LOCAL COMMENTERS

Subject: Draft Environmental Impact Report/Draft Environmental Impact Statement for the Folsom South of US Highway 50 Specific Plan, Folsom, Sacramento County, CA.

Mather Airport Planning Policy Area Boundary and Proximity to Folsom South SOI

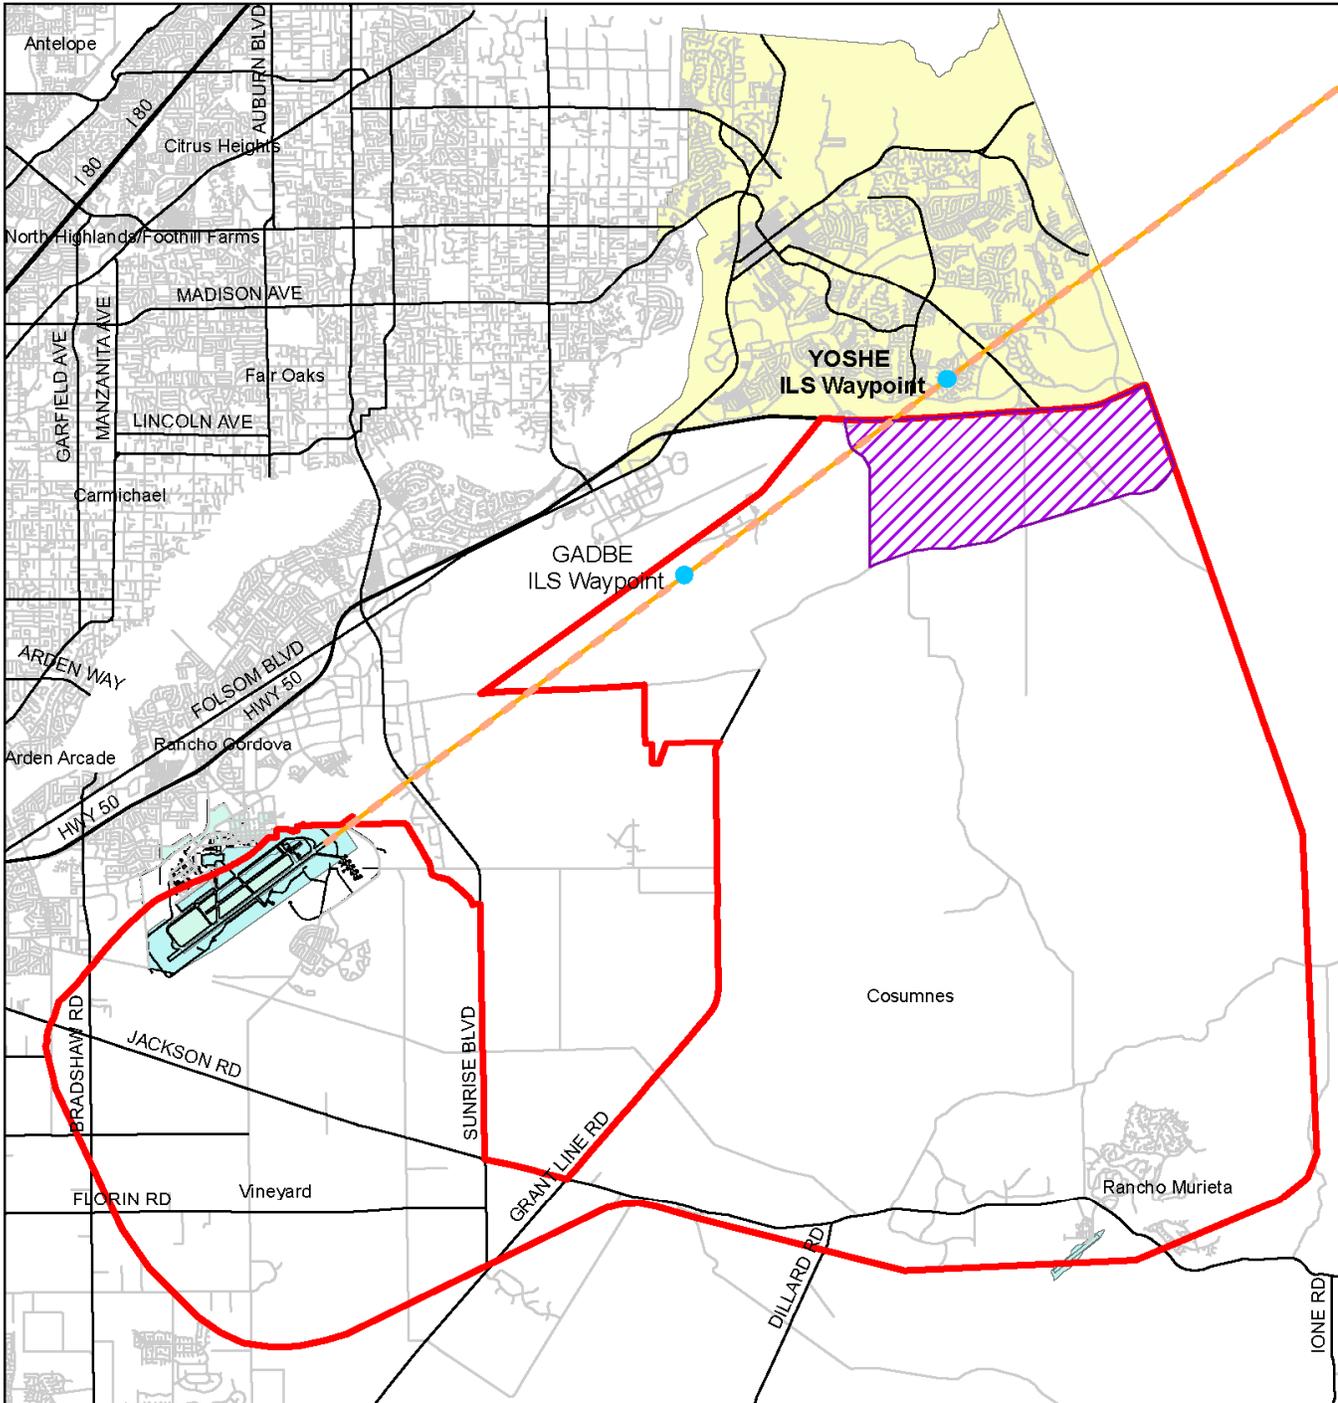
The Folsom South of U.S. 50 Specific Plan Project location is currently in an area of unincorporated Sacramento County and is entirely within the Mather Airfield APPA as depicted in Exhibit 4 (Attached). Under the No Project Alternative, the Project would be required to meet the conditions referenced above.

The comment states that the SPA is located in an unincorporated area of Sacramento County and is entirely within the MAPA, as shown in Exhibit 4 attached to the comment letter, and therefore under the No Project Alternative, the project would be required to meet the conditions referenced in comment Sac Cnty-2-184.

The City and USACE note that Exhibit 4 attached to Sacramento County's comment letter shows a different (i.e., larger) Sacramento County Mather Airport Planning Area Policy (MAPA) Boundary than what is depicted in the currently adopted and publically available 2005 MAPA. Furthermore, the County of Sacramento General Plan Noise Element, page 39, provides a codified map of the MAPA. As shown in the County General Plan Noise Element exhibit, the SPA does not lie within the MAPA. Finally, the City and USACE note that the City of Folsom is not within Sacramento County's MAPA Policy Boundary. As part of the project, the SPA would be annexed into the City of Folsom. Therefore, the SPA also would not be located within Sacramento County's MAPA Policy Boundary, and Sacramento County would not have land use planning jurisdiction or approval over the SPA. The comment raises no specific issues regarding the adequacy of the environmental analysis provided in the DEIR/DEIS. The comment does not specify additional information needed or particular insufficiencies in the DEIR/DEIS.

The SPA does not lie within the codified MAPA boundary shown in the adopted Sacramento County General Plan Noise Element. Exhibit 4 attached to Sacramento County's comment letter shows a different (i.e., larger) MAPA boundary than what is depicted in the currently adopted and publically available 2005 MAPA. However, regardless of these circumstances, under the No Project Alternative, the project would not be developed and the SPA would not be annexed into the City of Folsom. Therefore, under the No Project Alternative, Sacramento County would retain its land use planning jurisdiction and approval authority over the approximately 3,500-acre project site.
